MEMORANDUM

To: Jose Lopez, Project Manager, SDG&E
From: Jing Liang 
Date: 6/10/2010
Re: Mitigation Measure H-8a: Scour and Erosion Protection at Creek Crossings

RESPONSE TO MITIGATION MEASURE, H.8a: **BURY POWER LINE BELOW 100-YEAR SCOUR DEPTH.**

ALPINE BLVD. CREEK CROSSING

Upstream side of the creek

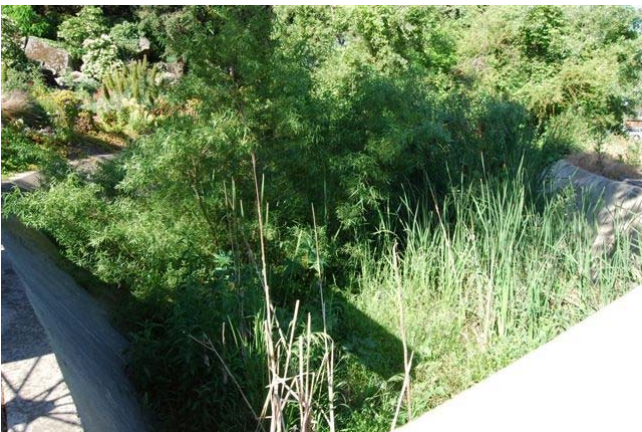
Data Request: B&V should provide a distance for which the stream was inspected in both in the

upstream and downstream direction. B&V should also provide representative photographs of the channel in the upstream and downstream directions.

Response: *B&V inspected approximately 50 feet from both upstream and downstream directions. Photos are included in the Attachment. Due to the heavy vegetation at both upstream and downstream next to the culvert, the erosion conditions can't be clearly seen from pictures. No obvious erosion or scour concerns were noticed. In addition, the heavy vegetation reinforces the soil and helps to prevent erosion and scour of stream beds.*
